Product Change Notification

Product Change Notification: E-20-012621

To revise TCPN: 988208-000 - NAE-143-3

failure mode image

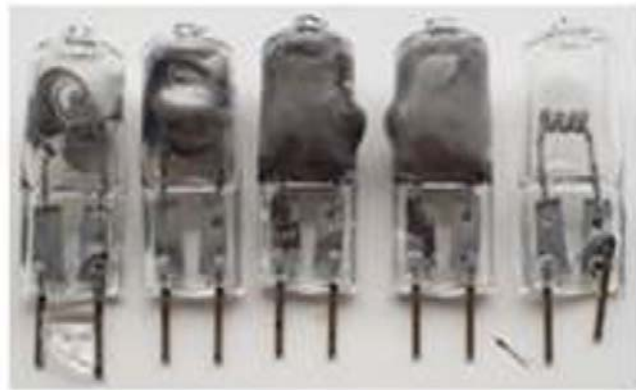
Form change - minor visual dissimilarity in overall length, the new lamp is 2 mm longer.

Manufacturing / Process Requirements. Due to changes in legislation, European suppliers have been phasing out halogen lamps for certain applications. As a result TE is working to ensure no disruption of product for our customers. Soon you will be receiving lamps that meet the EWX 24V 250W G6.35 specification but will exhibit a minor visual dissimilarity and a possible improvement in life expectancy when bulb is used with the IR1759 MiniRay Infrared Heat Tool product line. However the failure mode might be different refer attached image.
